SR 360 WIDENING
CSSTP-0006-00(049) - P.I. No. 0006049
Cobb and Paulding Counties, Georgia

Value Engineering Study Report
Preliminary Design Stage

re: Project No. CSSTP-0006-00(049), P.I. #0006049
Widening of SR 120/Charles Hardy Parkway to SR 176/Lost Mountain Road
Value Engineering Study Report

DRAWING No.
5-06

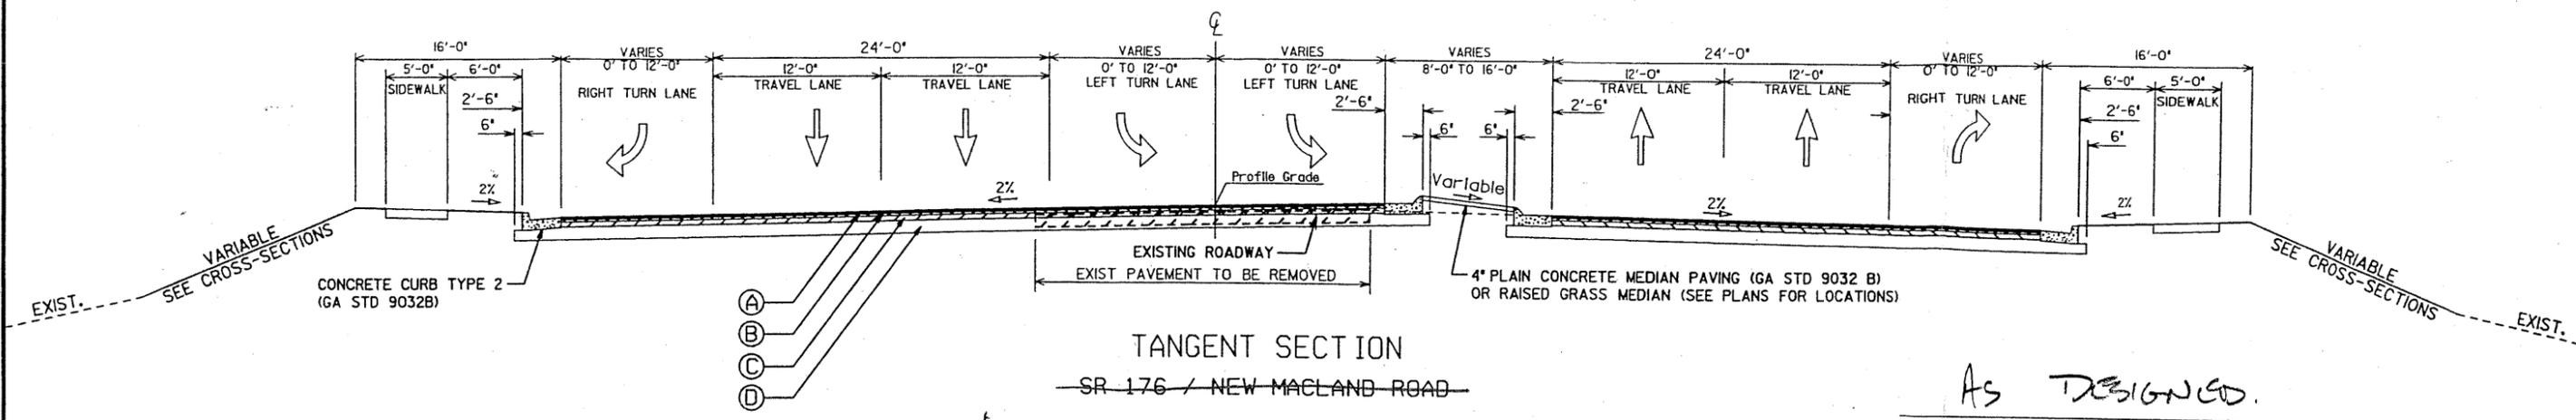
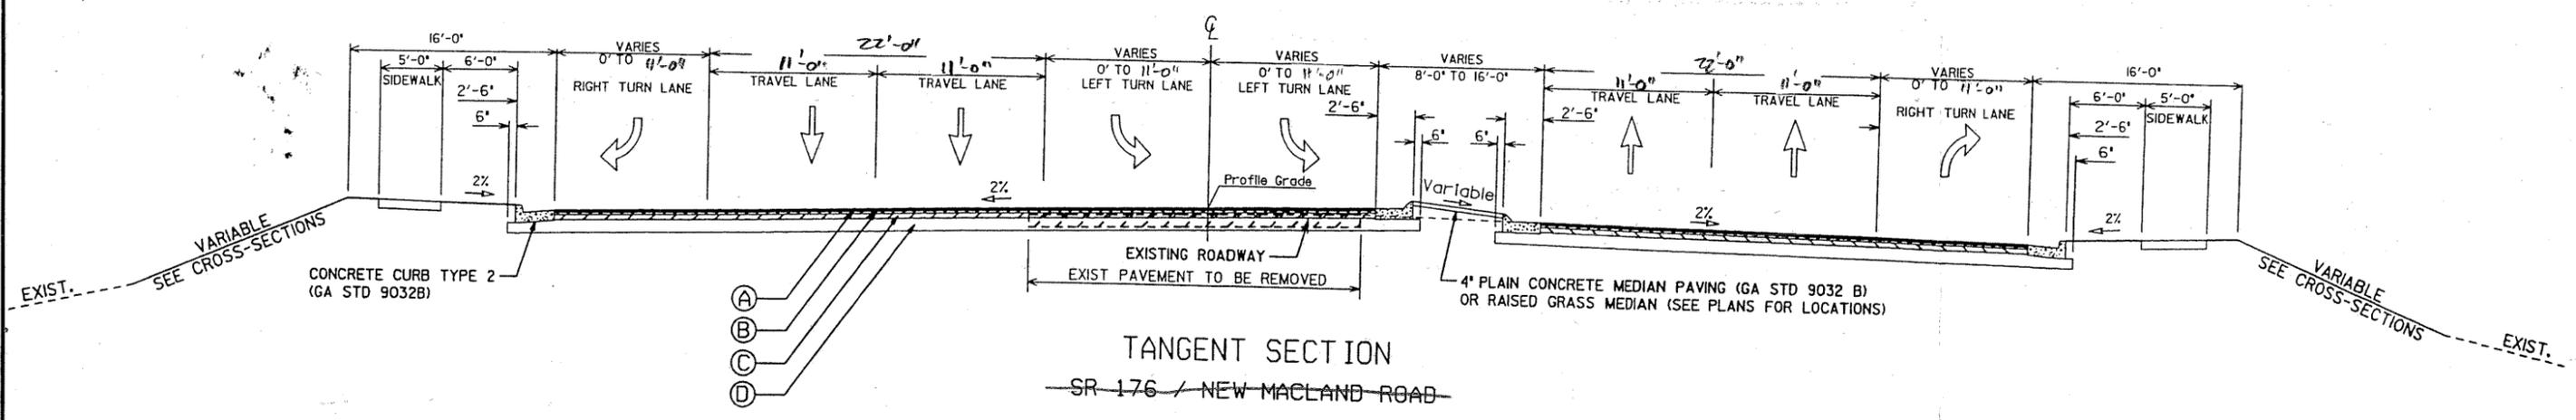
- Perceived “tight” or narrow turn lanes

The truck traffic percentage is low on this corridor. This in combination with a 45 mph design speed indicates that there is no need for 12-ft.-wide lanes. Eleven-ft.-wide lanes meet all Federal Highway Administration (FHWA) requirements for this route. With gutters at the edge of each edge lane, there is an extra margin of safety.

ALT P-6
Sht 2 of 6

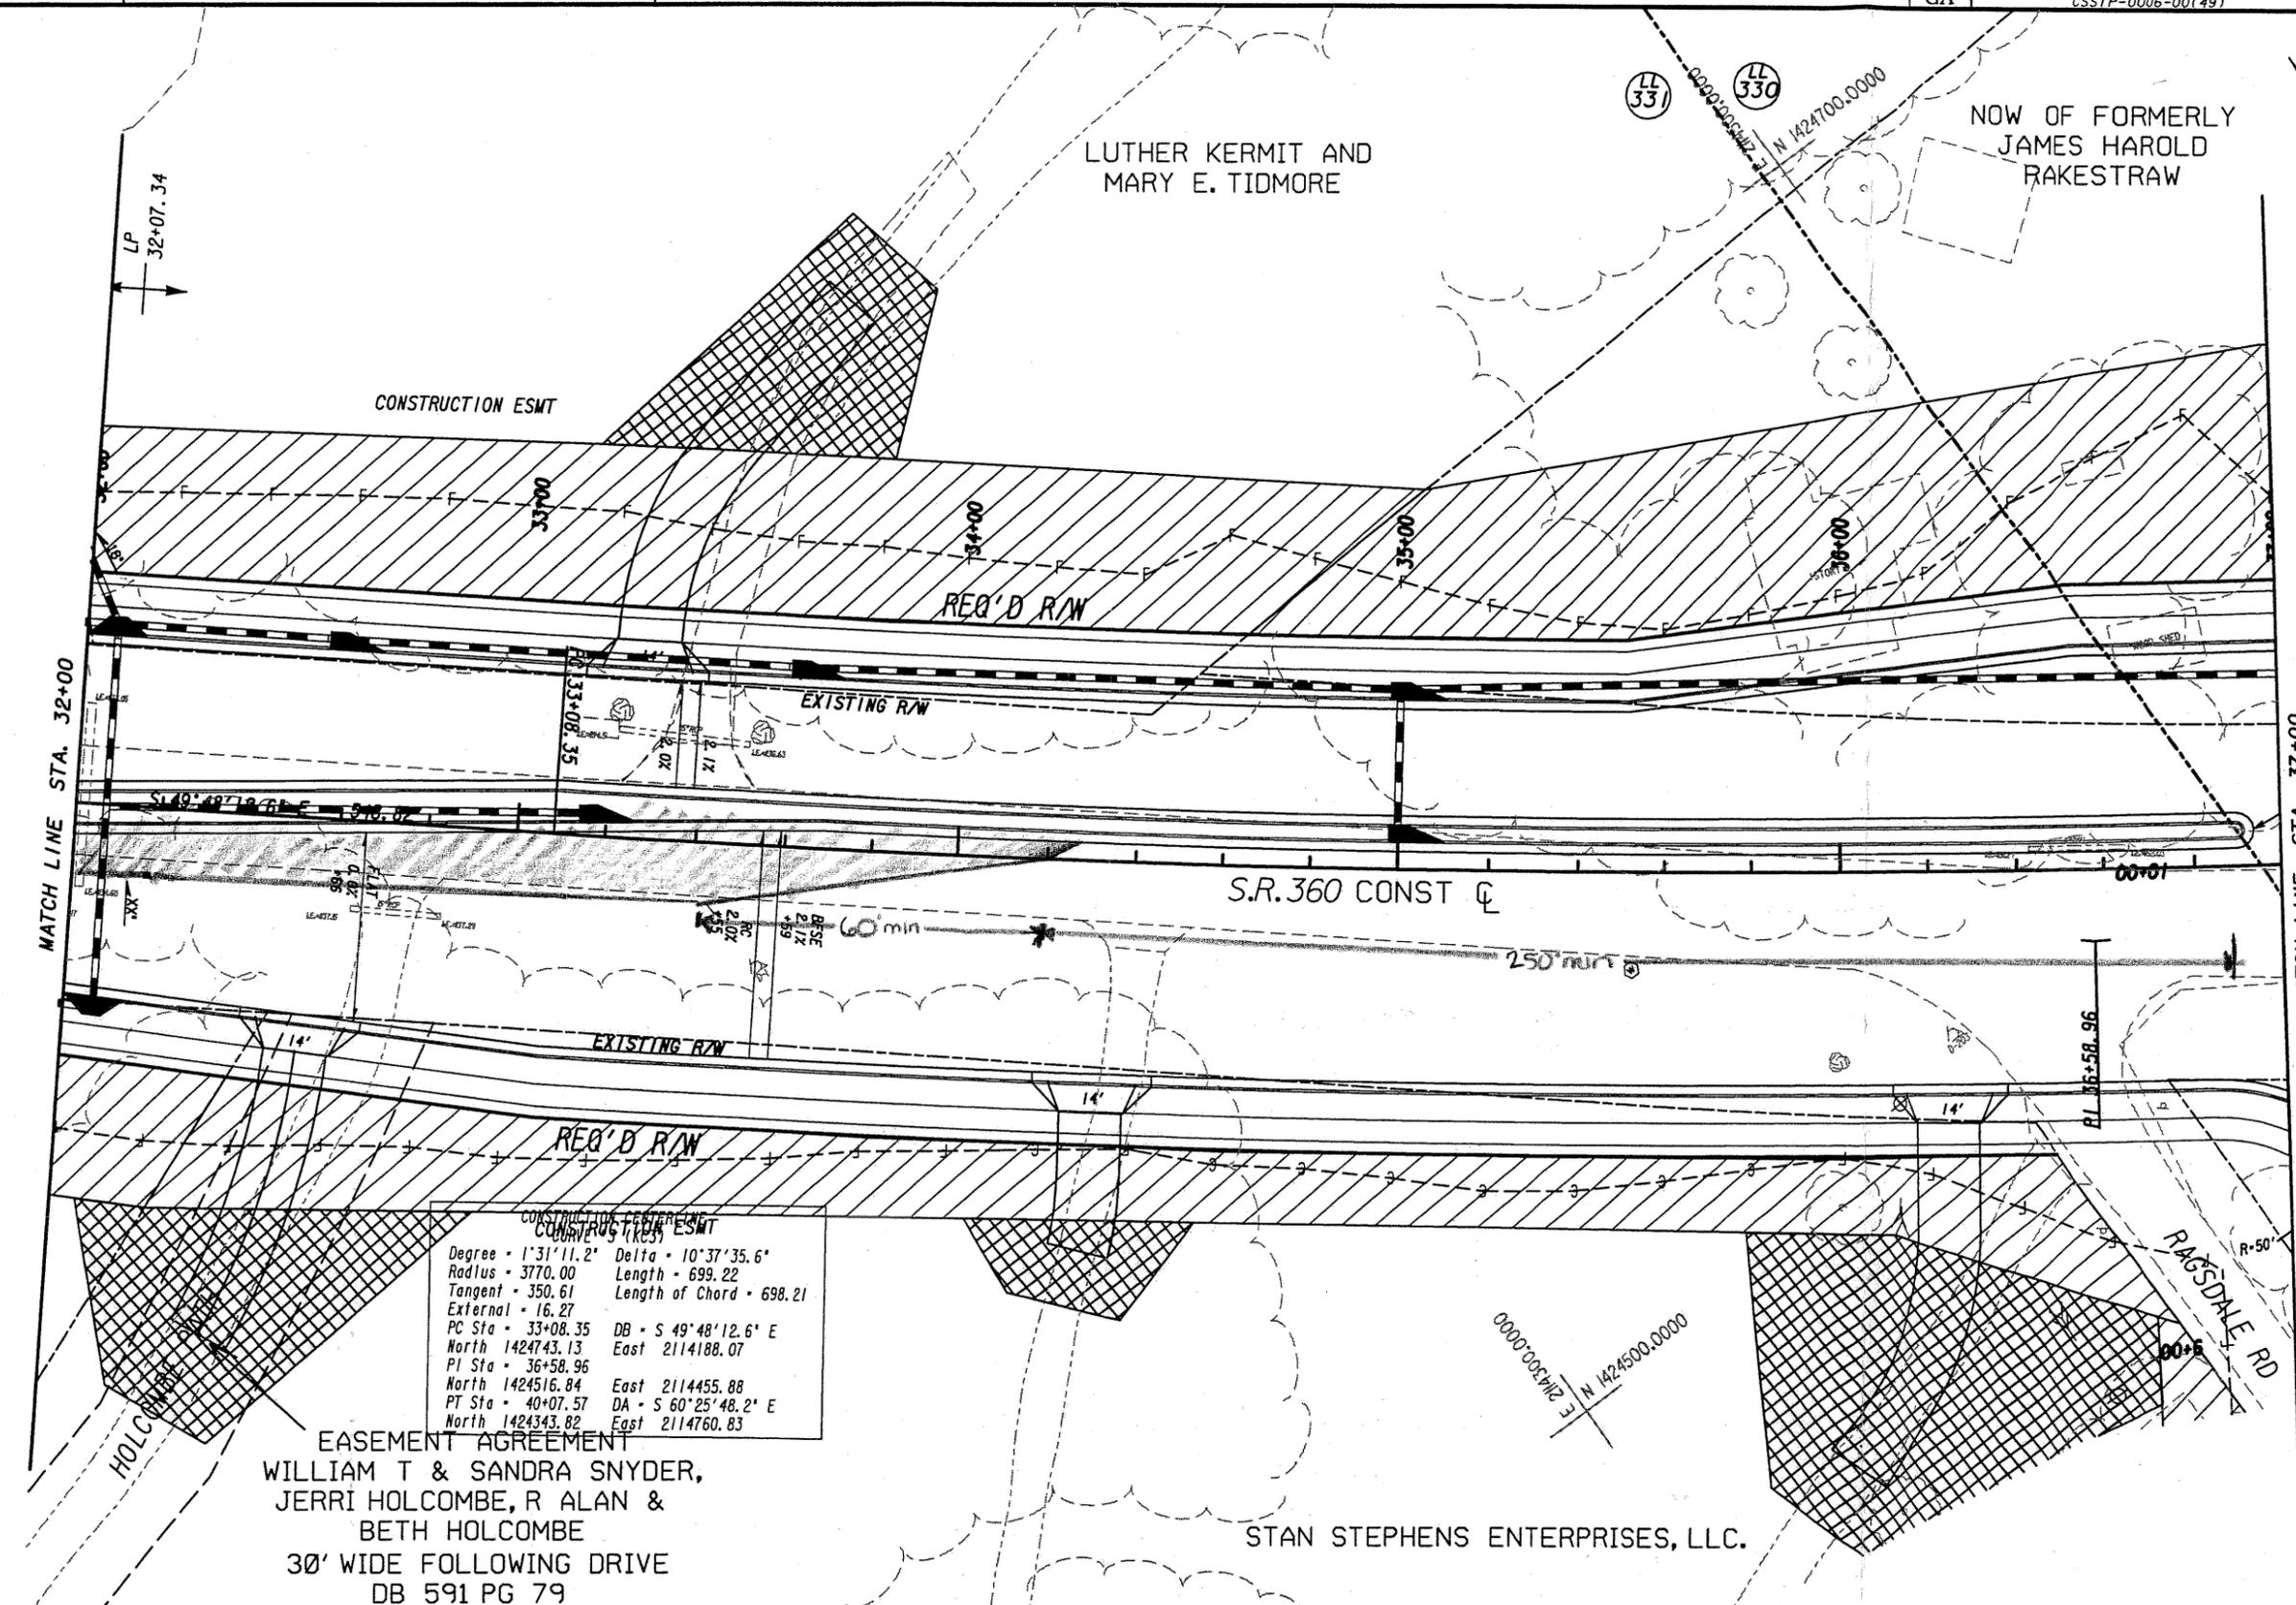
Use minimum storage lengths and taper lengths according to detail “M-3” to allow for fewer pavement areas where possible based on the traffic counts. The following listed left turns (median openings) can be shorted to the minimum: STA 37+00 (sht 05 and 06), STA 52+60 (sht 08 and 09), STA 64+80 (sht 10-12), STA 81+20 (Macland Road/Old Mill Road-sht 14), STA 121+00 (U-turn traveling westbound), STA 135+00 (Lake Road/Smith Road), STA 157+20 (U-turn), STA 191+00 (U-turn), STA-201+00 (U-turn), STA 210+40 (sht 13-37-church) (STA 263+00 (Lire Tree Lane), and STA 307+00 (U-turn).
